SUBJECT: ISSUANCE OF AMENDMENTS (TAC NOS. 79440 AND 79441)

The Commission has issued the enclosed Amendment No. 30 to Facility Operating License No. NPF-72 and Amendment No. 30 to Facility Operating License No. NPF-77 for the Braidwood Station, Unit Nos. 1 and 2, respectively. The amendments are in response to your application dated December 19, 1990.

The amendments revise the Braidwood Station, Unit 2, Technical Specifications (TS) by changing the heatup and cooldown curves, the power operated relief valve Low Temperature Overpressure Protection (LTOP) setpoints and their bases. These amendments also shorten the applicability of the Braidwood, Unit 1, heatup and cooldown curves.

SAFETY EVALUATION BY THE OFFICE OF NUCLEAR REACTOR REGULATION  
RELATED TO AMENDMENT NO. 30 TO FACILITY OPERATING LICENSE NO. NPF-72  
AND AMENDMENT NO. 30 TO FACILITY OPERATING LICENSE NO. NPF-77

**FIGURE 3.4-2a**  
**REACTOR COOLANT SYSTEM HEATUP LIMITATIONS**  
**APPLICABLE UP TO 32 EFY\*(UNIT 1)**

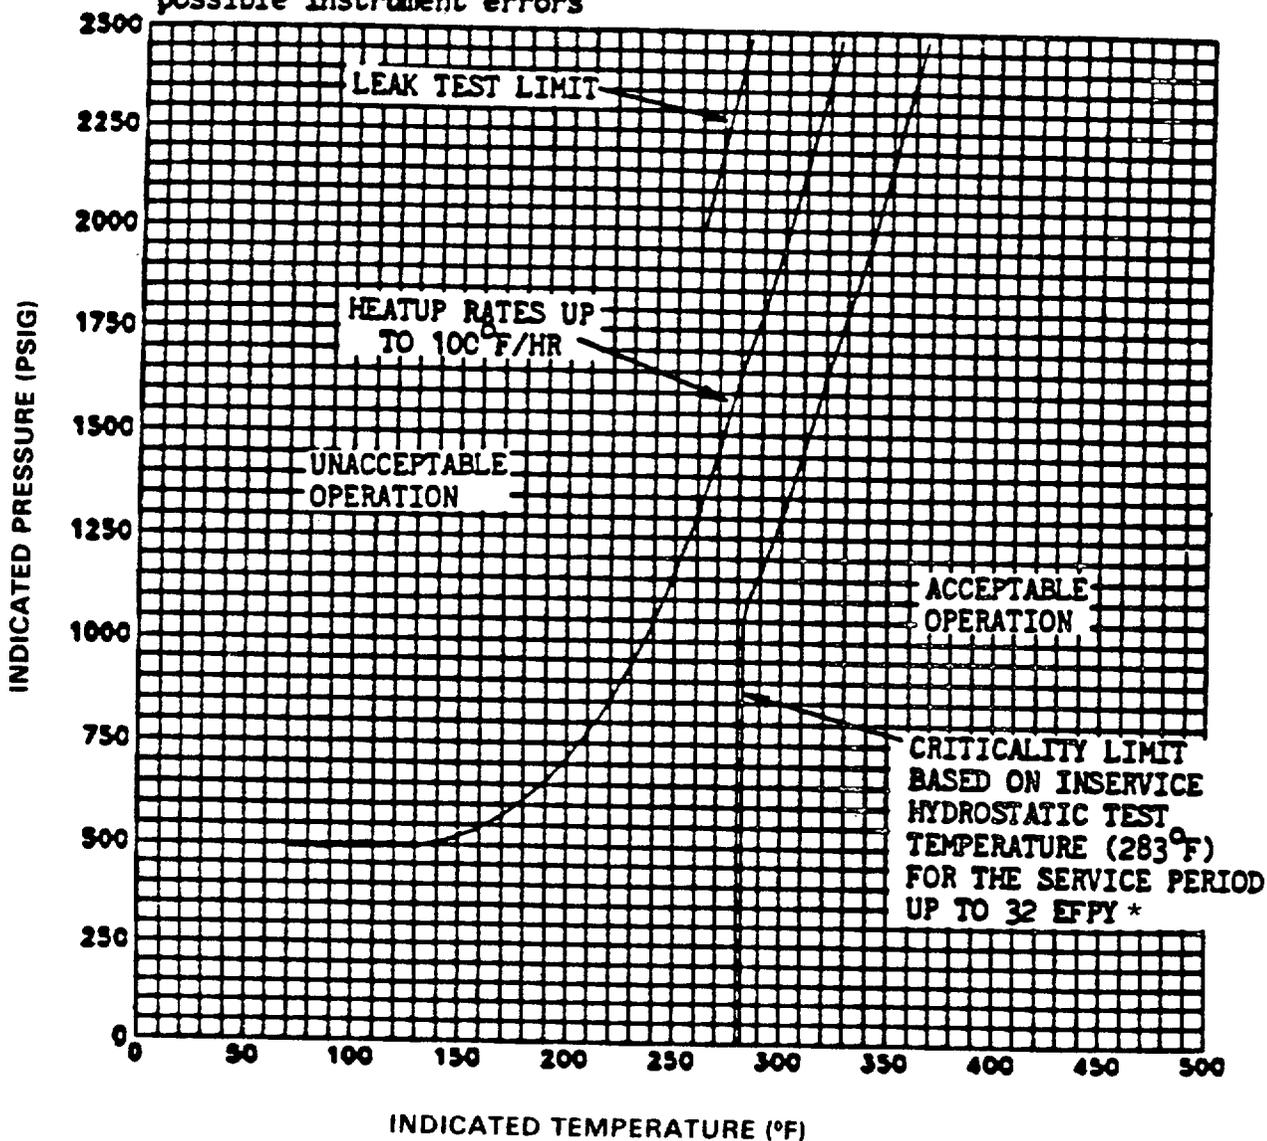
\*applicability date has been reduced per Regulatory Guide 1.99 Revision 2 to 4.5 EFY. The calculation to determine applicability utilized actual copper content of 0.05 wt%.

For the limiting beltline, circumferential weld (WF562), the staff calculated the ART to be 109.2°F at 1/4T (T = reactor vessel beltline thickness) and 84.2°F for 3/4T at 4.5 EFPY. The staff used a neutron fluence of 2.67E18 n/cm<sup>2</sup> at 1/4T and 9.6E17 n/cm<sup>2</sup> at 3/4T. For the same weld, the staff calculated the ART to be 137.8°F at 1/4T and 108.2°F for 3/4T at 12 EFPY. The staff used a neutron fluence of 7.13E18 n/cm<sup>2</sup> at 1/4T and 2.57E18 n/cm<sup>2</sup> at 3/4T for 12 EFPY. The ART was determined using Section 1 of RG 1.99, Revision 2, because only one surveillance capsule has been withdrawn from Braidwood Unit 1.

The licensee used the method in RG 1.99 Revision 2, to calculate an ART of 109°F at 4.5 EFPY at 1/4T for the same limiting weld metal. The staff judges that a difference of 0.2°F is acceptable. Substituting the ART of 109.2°F into equations in SRP 5.3.2, the staff verified that the proposed P/T limits for heatup and hydrotest meet the beltline material requirements in Appendix G of 10 CFR Part 50.

The staff concludes for Braidwood Unit 1 that the proposed heatup, leak test, and criticality limits are valid up to 4.5 EFPY and cooldown limits are valid up to 12 EFPY because the limits conform to the requirements of

FIGURE 3.4-2b

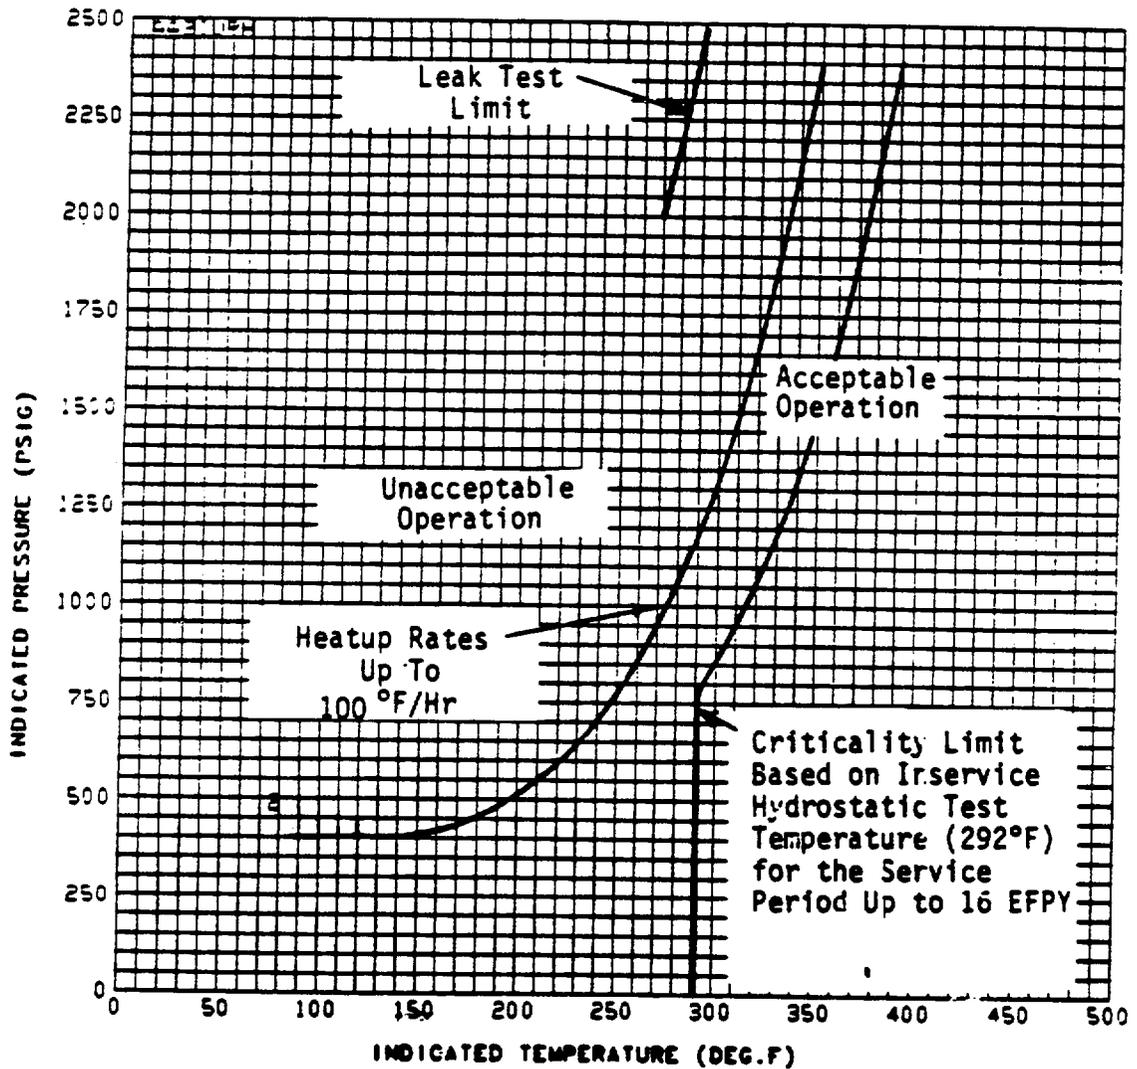
For the limiting beltline material, circumferential weld WF562, the staff calculated the ART to be 146.6°F at 1/4T (T = reactor vessel beltline thickness) and 116.2°F for 3/4T at 16 EFY. The staff used a neutron fluence of 9.54E18 n/cm<sup>2</sup> at 1/4T and 3.44E18 n/cm<sup>2</sup> at 3/4T.

The licensee used the method in RG 1.99, Revision 2, to calculate an ART of 146.5°F at 16 EFY at 1/4T for the same limiting weld metal. Substituting the ART of 146.6°F into equations in SRP 5.3.2, the staff verified that the proposed P/T limits for heatup, cooldown, and hydrotest meet the beltline material requirements in Appendix G of 10 CFR Part 50.

The staff concludes that for Braidwood Unit 2 the proposed P/T limits for the reactor coolant system for heatup, cooldown, leak test, and criticality are valid up to 16 EFY because the limits conform to the requirements of Appendices G and H of 10 CFR Part 50. The limits also satisfy GL 88-11 because the licensee used the method in RG 1.99, Revision 2 to calculate the ART. Hence, the proposed P/T limits may be incorporated into the Braidwood Unit 2 TSs.

FIGURE 3.4-3a

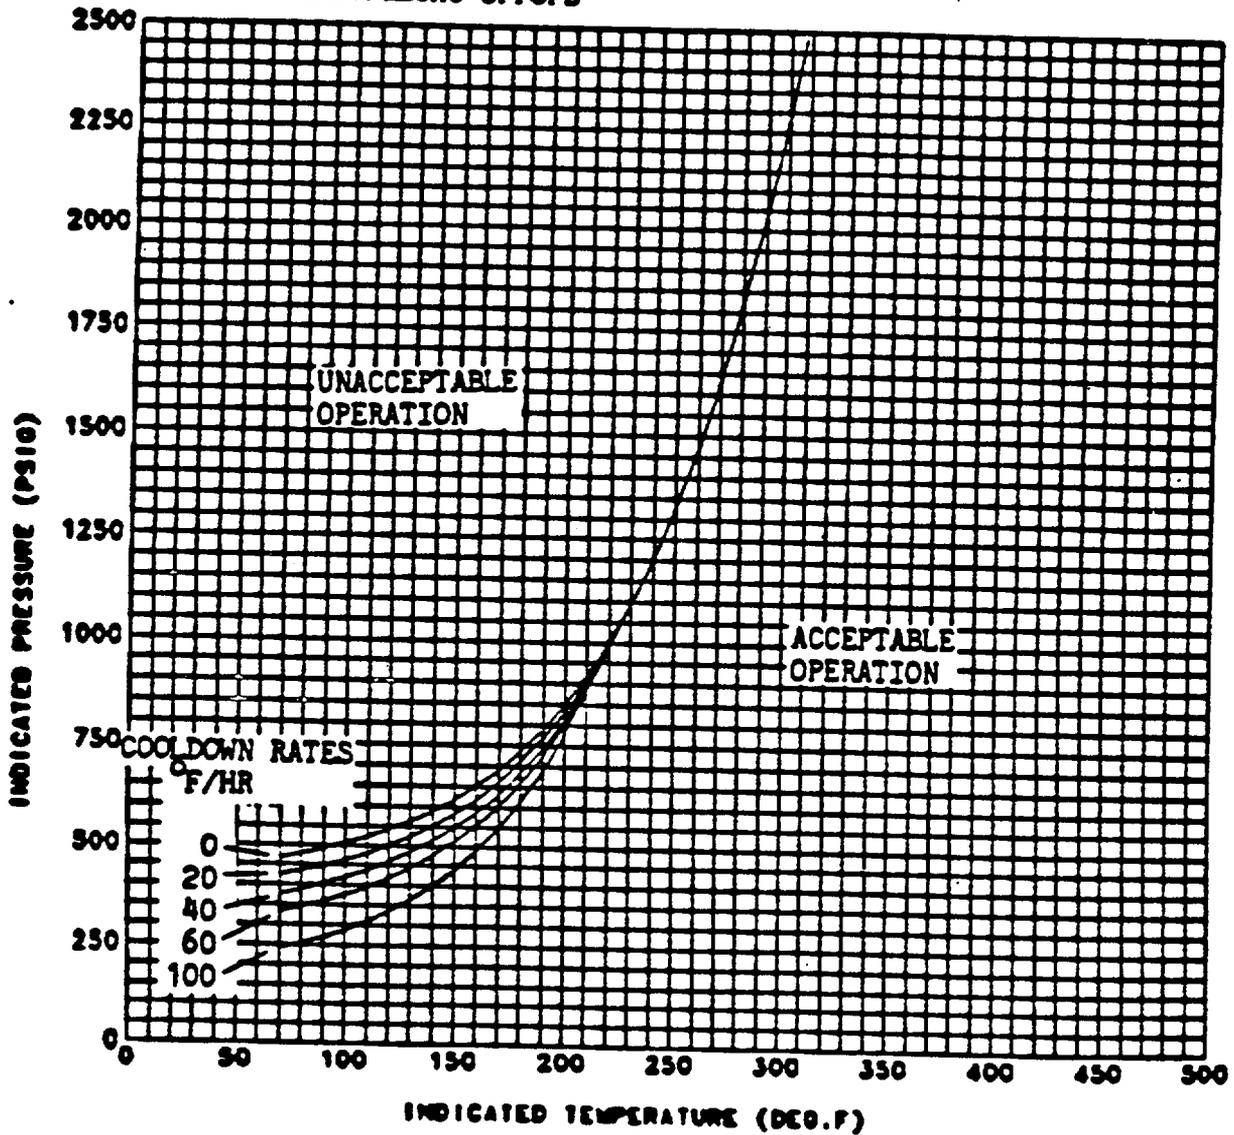
\*applicability has been reduced per Regulatory Guide 1.99 Revision 2 to 12 EFPY. The calculation to determine applicability utilized actual copper content of 0.05 wt%.

For the cooldown limits, the licensee calculated an ART of 138°F at 12 EFPY at 1/4T for the same limiting weld metal. The staff judges that the licensee's ART of 138°F is more conservative than the staff's ART of 137.8°F, and it is acceptable. Substituting the ART of 138°F into equations in SRP 5.3.2, the staff verified that the proposed P/T limits for cooldown meet the beltline material requirements in Appendix G of 10 CFR Part 50.

FIGURE 3.4-4a

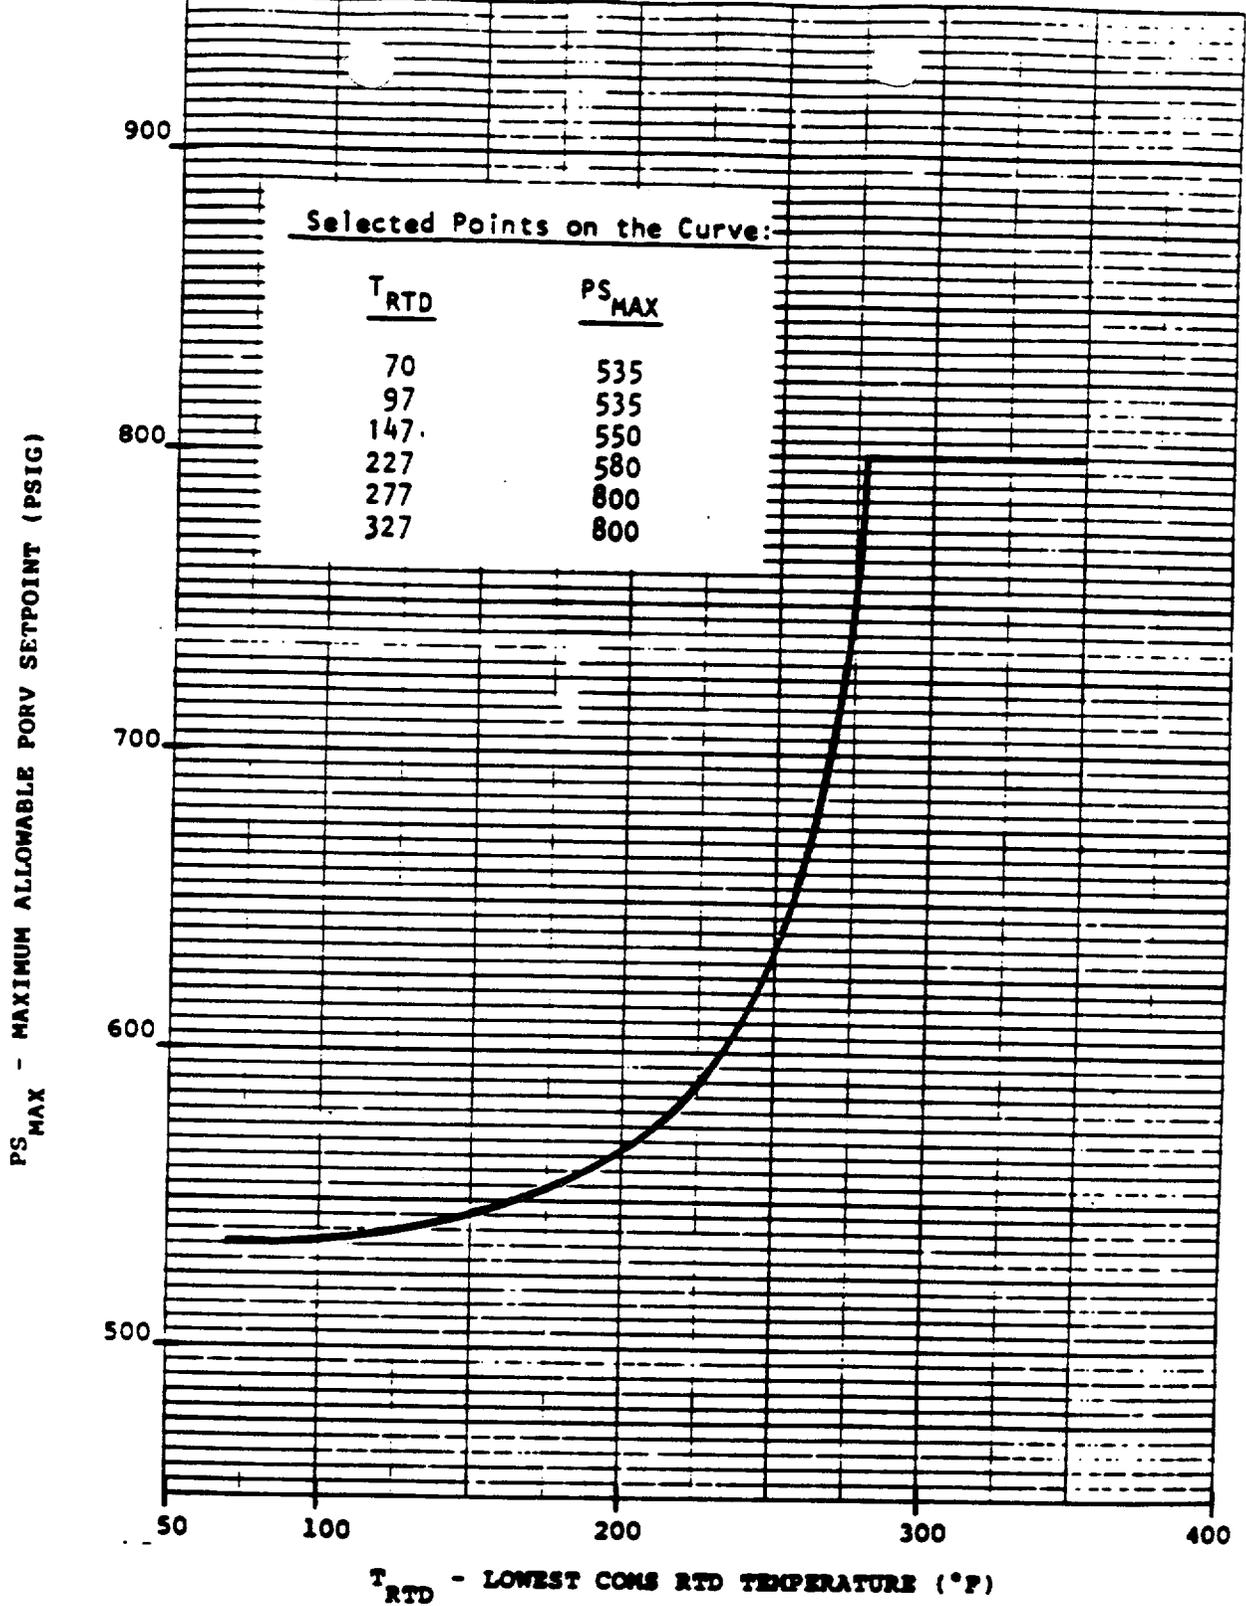
\*applicability has been reduced per Regulatory Guide 1.99 Revision 2 to 4.5 EFPY.  
The calculation to determine applicability utilized actual copper content of 0.05 wt%.

These two scenarios are analyzed to determine the resulting overshoots assuming a single PORV actuation with a stroke time of 2.0 seconds from full closed to full open. Figure 3.4-4a (3.4-4b) are based upon this analysis and represents the maximum allowable PORV variable setpoint such that, for the two overpressurization transients noted, the resulting pressure will not exceed the Appendix G reactor vessel NDT limits.
